# National Fenestration Rating Council Incorporated

NFRC 2010 Technical Interpretations Manual E0A8

Published: December 8, 2011
-----------------------------

D200 Door Inside Storefront Framing System

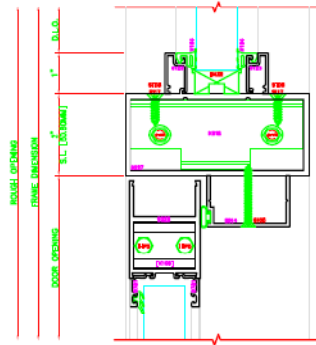
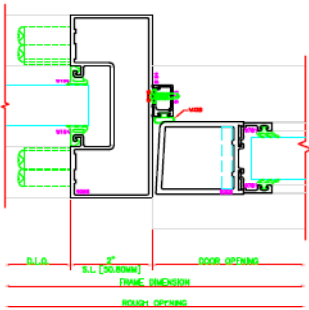
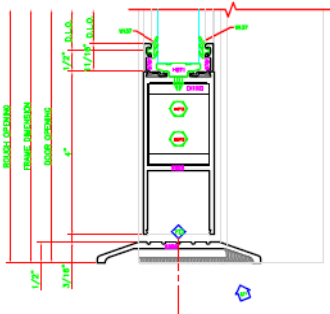
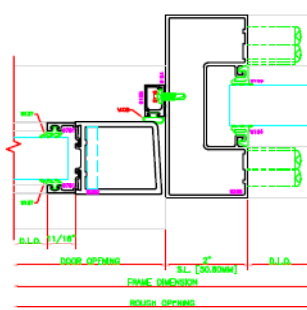
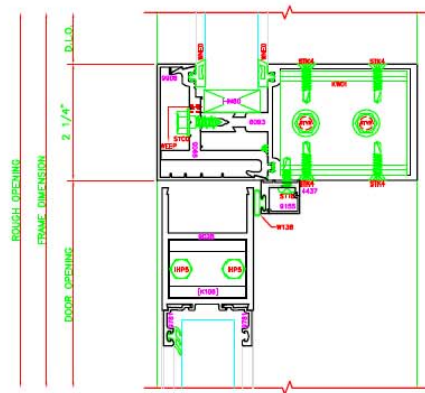
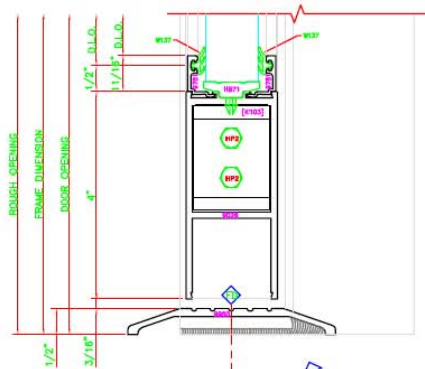
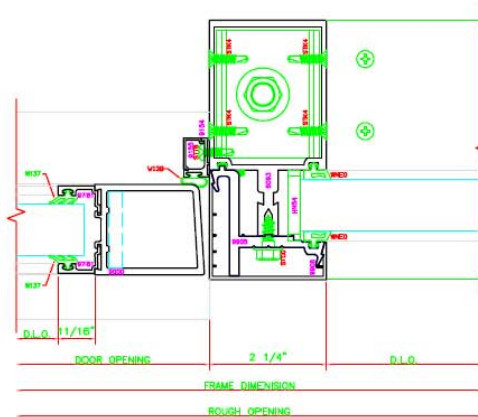
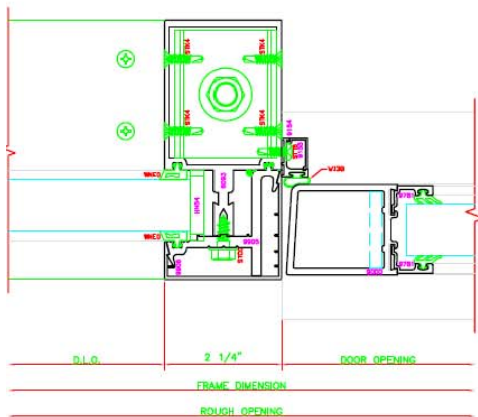
How should a door which is designed to be installed in a variety of curtain wall / storefront systems be rated?

The door shall be rated in the curtain wall/storefront system framing it is installed.

Example 1

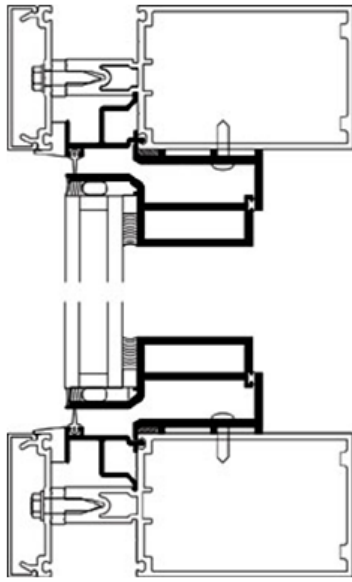
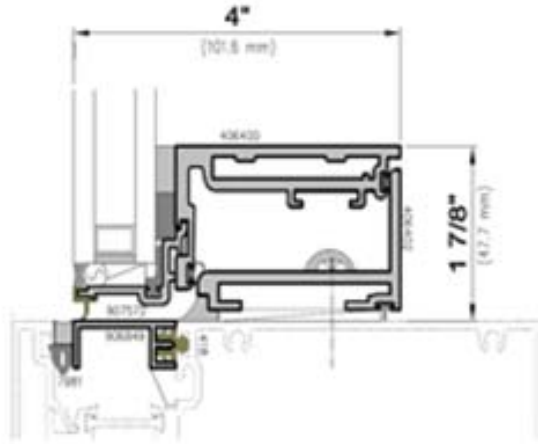
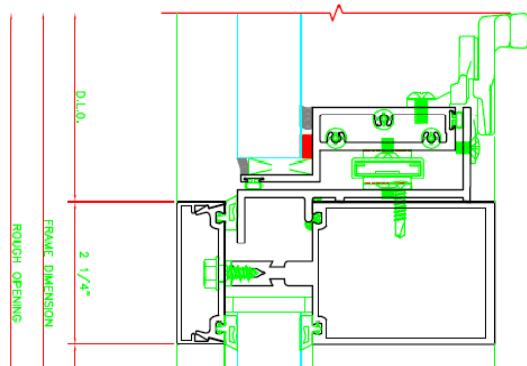
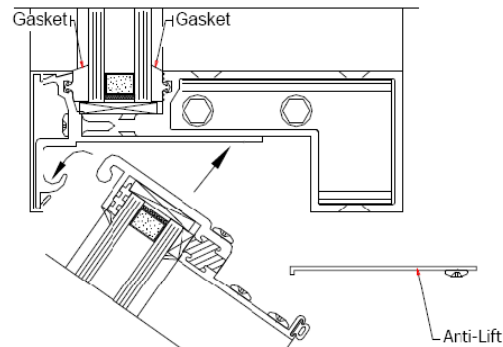
Concealed vents are a type of 4-sided structurally glazed window that are commonly used in commercial fenestration. Since there is no exposed framing on the exterior of the window, the window obtains its strength by attaching directly to a curtain wall. For validation testing purposes it is necessary to include the support framing in the test. However, since concealed vents are never installed as single openings but are part of a larger glazed wall system, it should be permitted that the simulations are done to the centerline of the support framing system into which they are installed. This is consistent with footnote 4 of table 4-3 which allows simulations to be done to the centerline of the verticals and horizontals. The validation test size would continue to be based on the size for the operator size in table 4-3 including the full frame of the glazed wall system. Simulating the full frame penalizes the product since half of the frame is already being included in the glazed wall simulations. See example of a concealed vent installed into a curtain wall system below. Requested interpretation on the following two questions is requested:

- How are concealed vents to be tested?
- How are concealed vents to be simulated and rated?

All vents designed to go into glazed walls shall be tested and rated as a stand-alone product, using the appropriate operator type from Table 4-3 of NFRC 100.

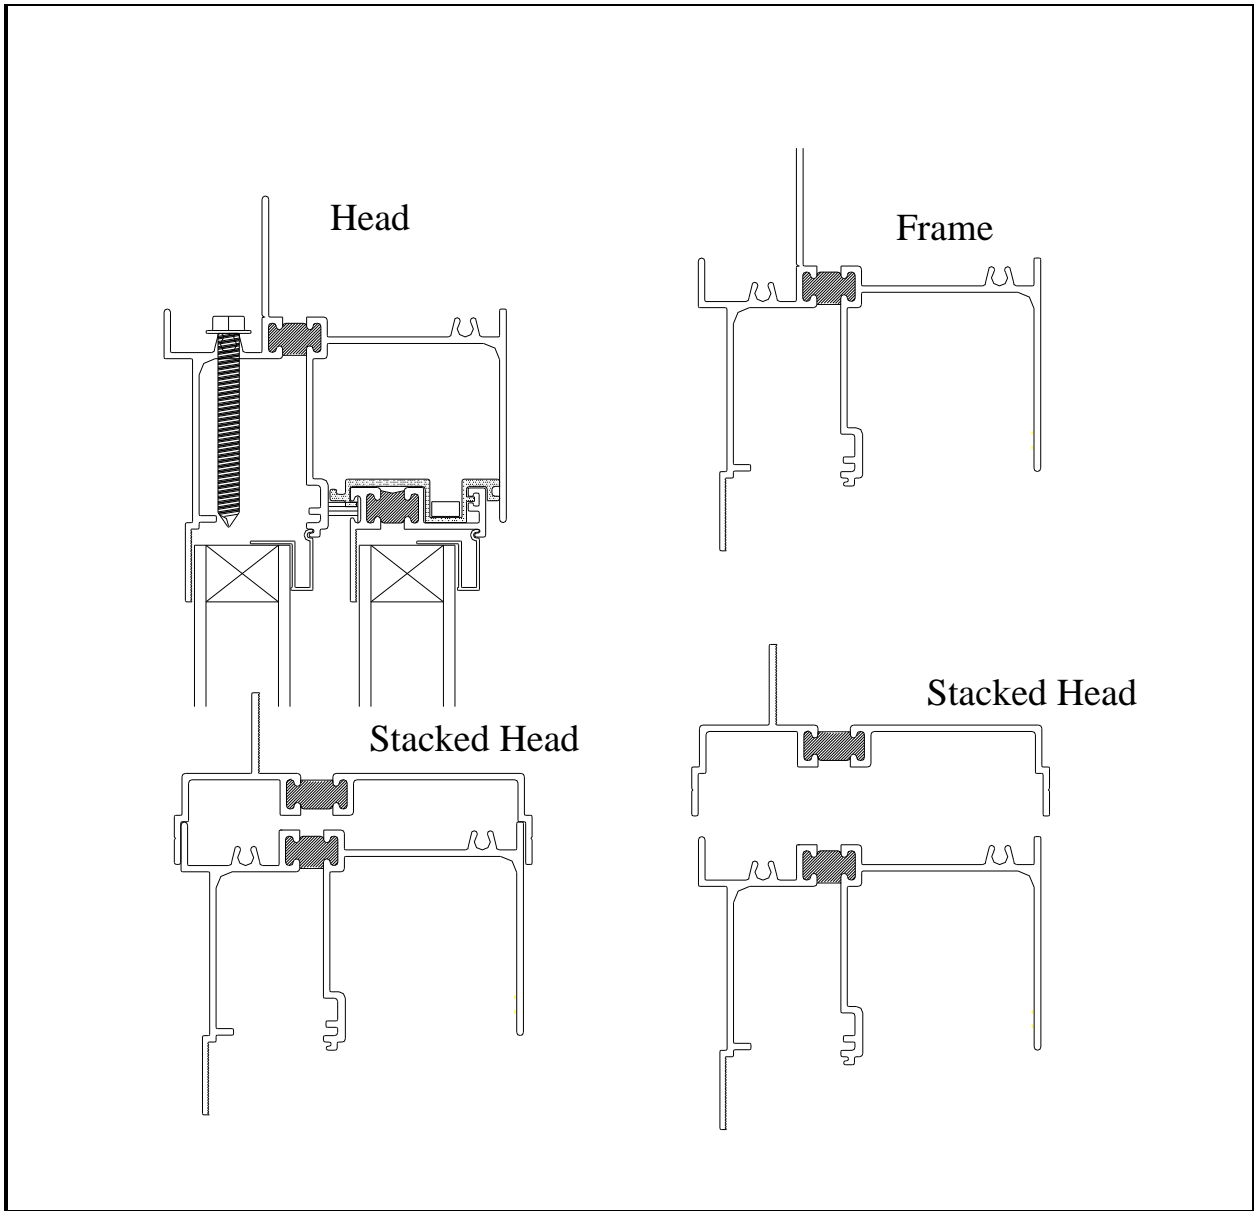
<b><i>Interpretation Requested:</i></b>
Are additional profiles attached to the perimeter of a window frame to be modeled as part of the same product line? Is it an individual product within a product line?

<b><i>Interpretation:</i></b>
No. The fenestration product with the additional attached profile is to be treated as a separate product line. (See the example below)

Figure 1

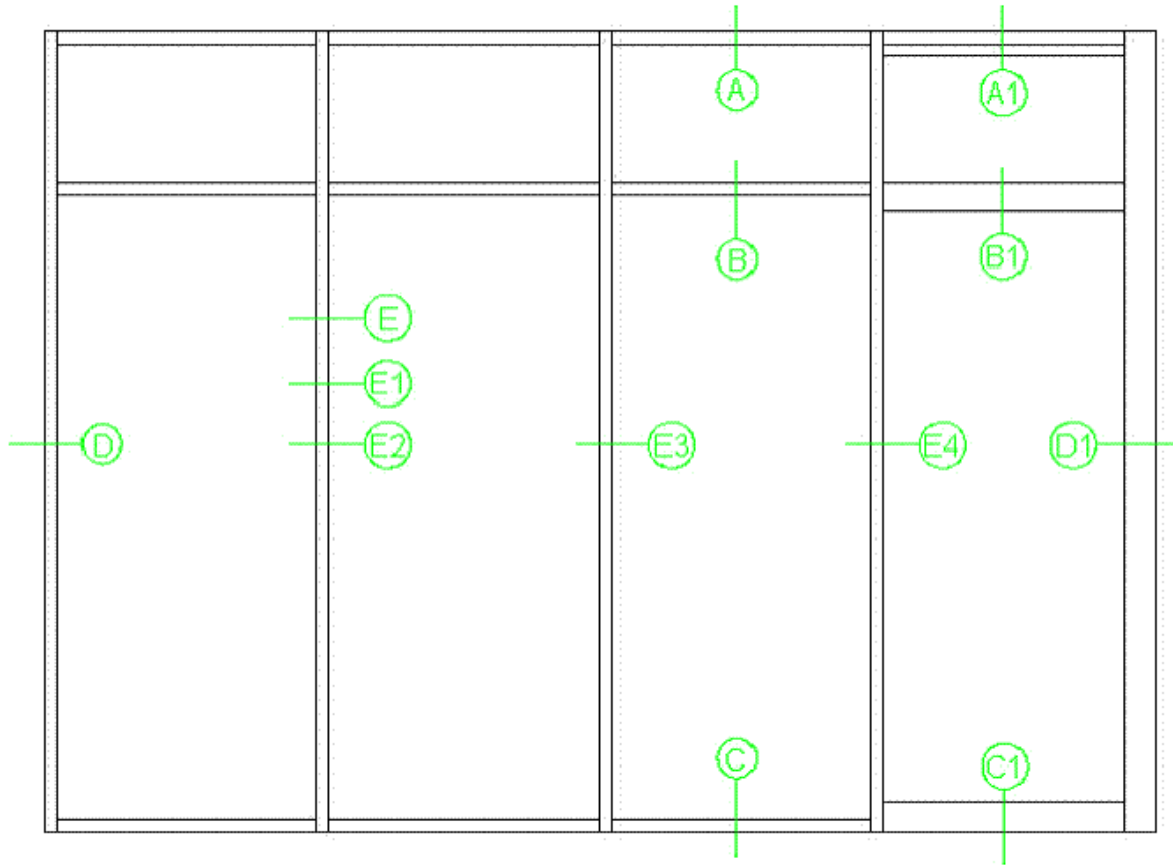
<b><i>Interpretation Requested:</i></b>
Please provide general clarification on modeling a store front system given in Figure 1 and how to select a typical cross section for modeling the intermediate verticals as jamb in a window wall system.

<b><i>Interpretation:</i></b>
The store front system shall be simulated as a Glazed Window Walls System. As per footnote #5, Window Walls shall be simulated and tested with intermediate verticals as jamb (using half of jamb for U-factor tag) and standard head and sill members. If the intermediate verticals are not the same, then they can either be simulated as different product lines, or grouped, if applicable. The horizontals in the storefront system, other than the door transom, shall be ignored. The door and transom, if present shall be each simulated separately. For door and transom use standard jamb definition (i.e., full U-factor tag).

# Sill in Flooring

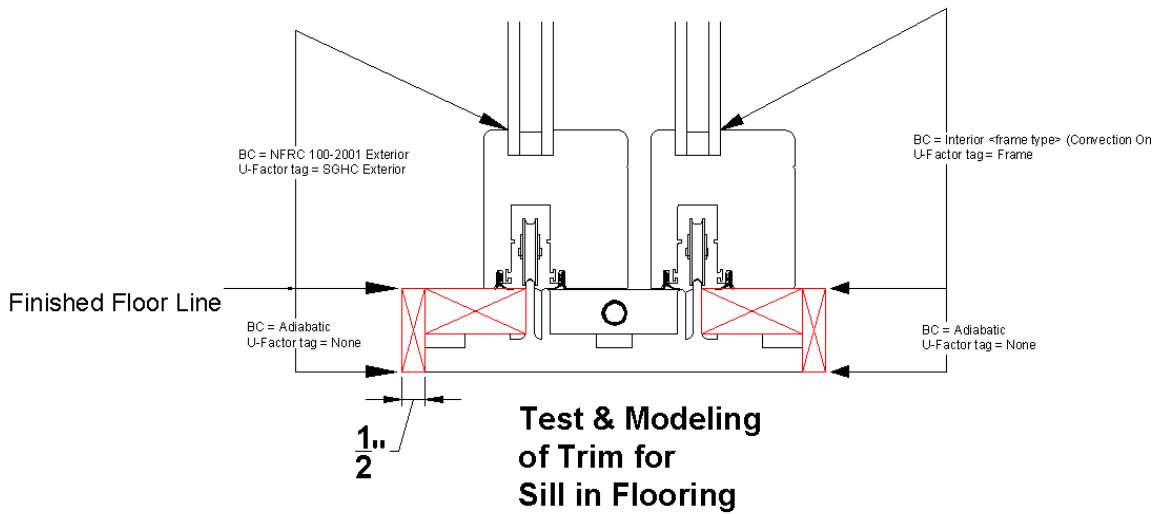
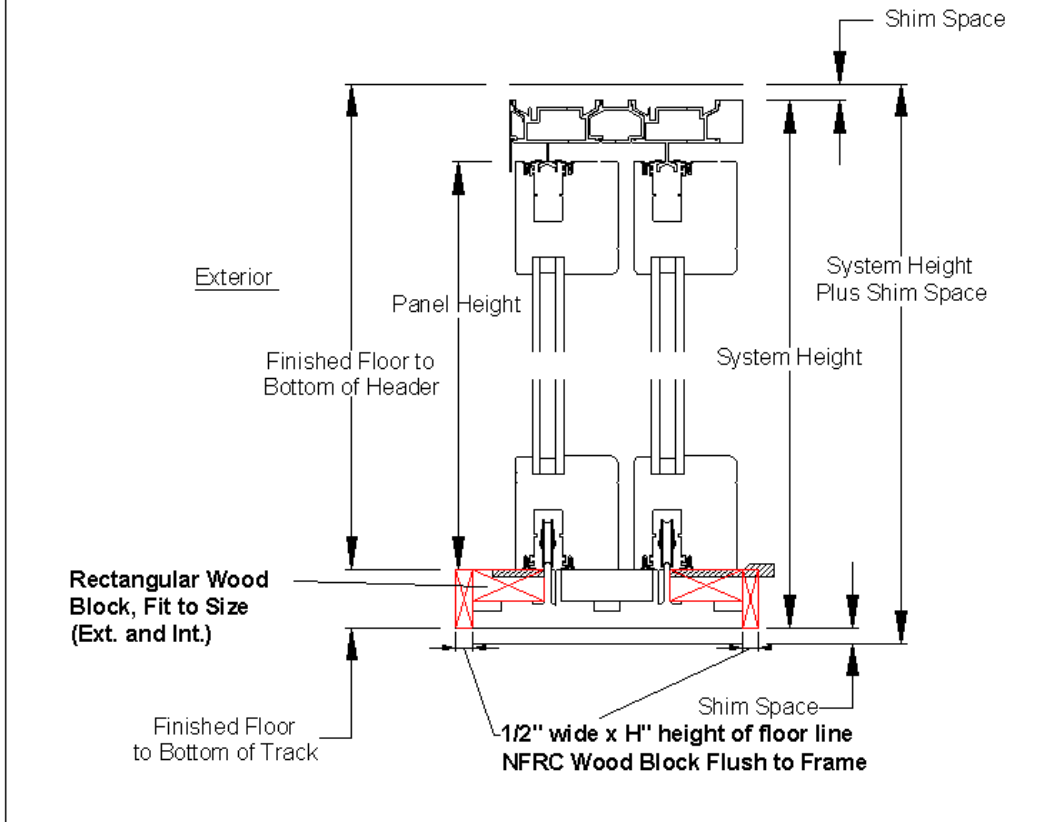
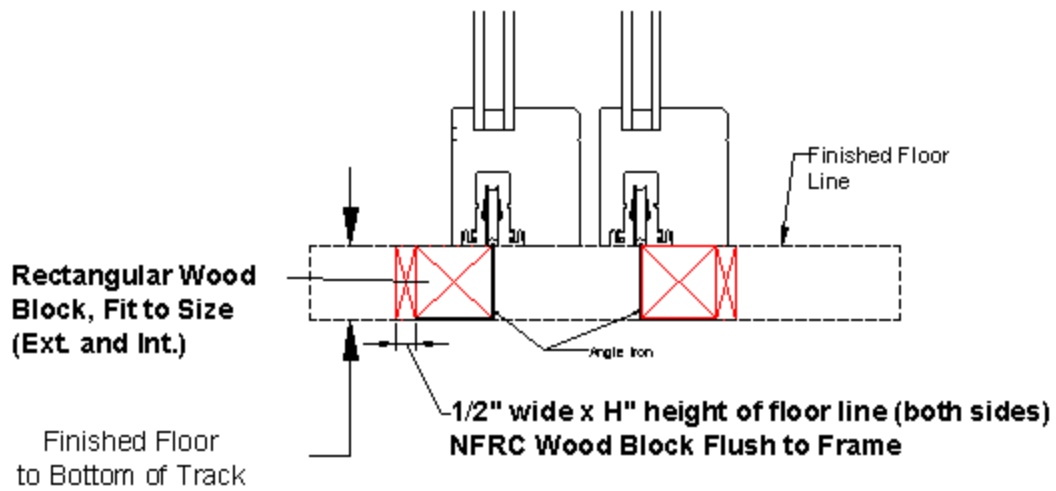
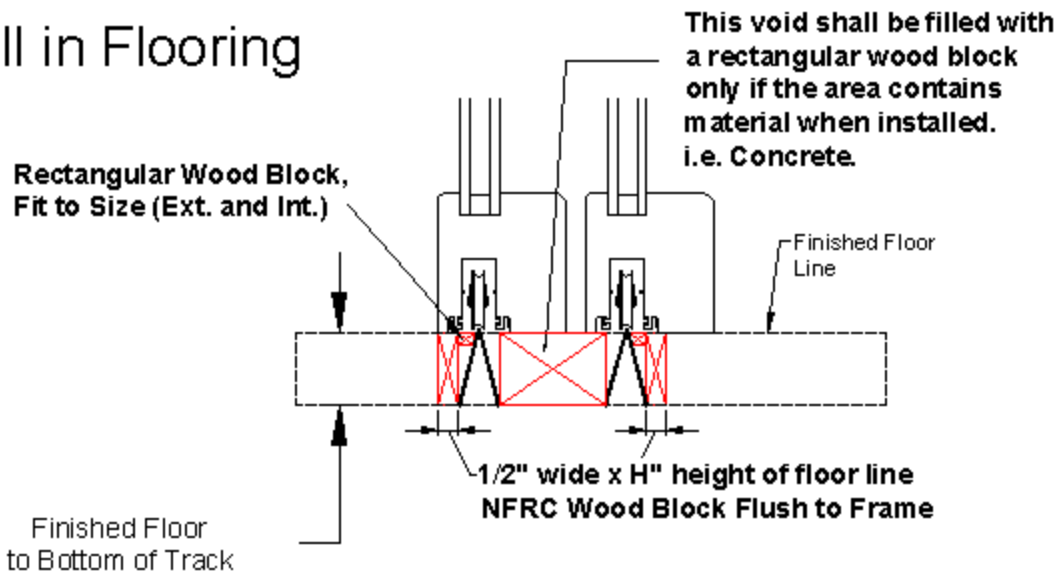
If the sill of a sliding glass door is designed set into the building; installed so that it extends beyond the rough opening, is it considered an appendage and therefore not modeled?

No, although the integral framing member (in this case the sill) extends beyond the rough opening and is not exposed after installation, it shall be modeled in the following manner:

A rectangular wood block (pine or equivalent) ½” x H” (height from the bottom of the sill cavity to the finish floor line) shall be placed from at the edge of the frame on both the exterior and interior.

A rectangular wood block shall be sized to fit the exterior and interior area void created between the ½” block and the sill roller track.

If applicable, any remaining center void that is intended to be filled with material (i.e., concrete) when the unit is installed, a rectangular wood block shall be sized to fit the area.

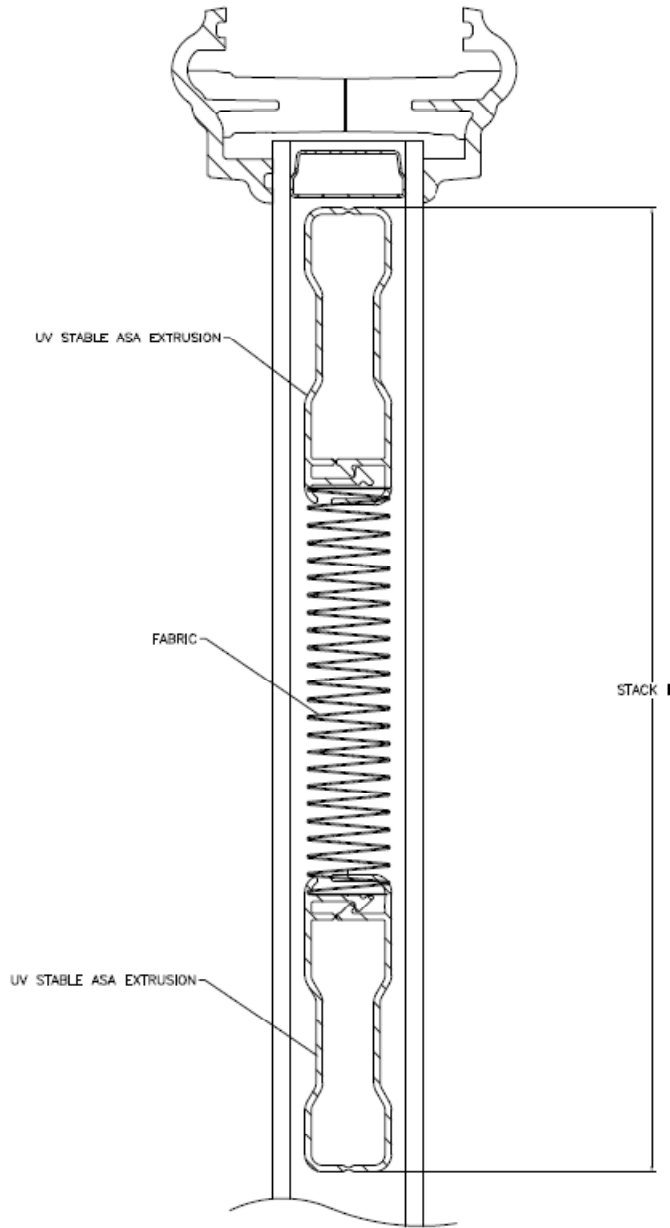
<b><i>Interpretation Requested:</i></b>
Can a fabric shade between the glass be simulated and rated in the fully retracted position?

<b><i>Interpretation:</i></b>
Yes. The technique shown in Section 8.11 of the Simulation Manual shall be used, provided the shade system is designed to be stacked in the retracted position, with a solid block of “Cellulosic Fiber, Cotton Fiber” as the shade material in the model (See Model on next page)

DEFAULT NON-THERMALLY BROKEN SILL  
ALUMINUM, MILL FINISH

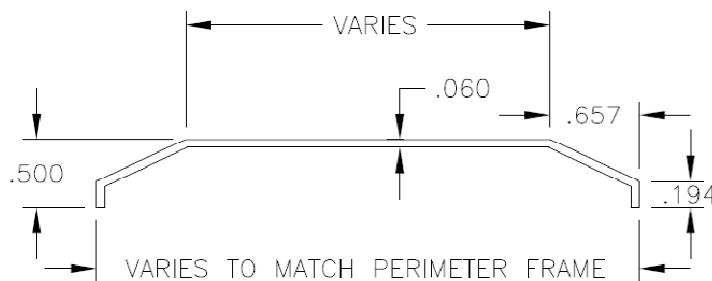
When simulating the default steel frame for doors, what sill should be used?

An aluminum non-thermally broken sill with a sill wall thickness of 1.4 mm to 1.6 mm (0.055 in to 0.065 in) and no substrate, as indicated in Section 5.2.4.B of NFRC 100-2010. (The attached drawing may be used.)
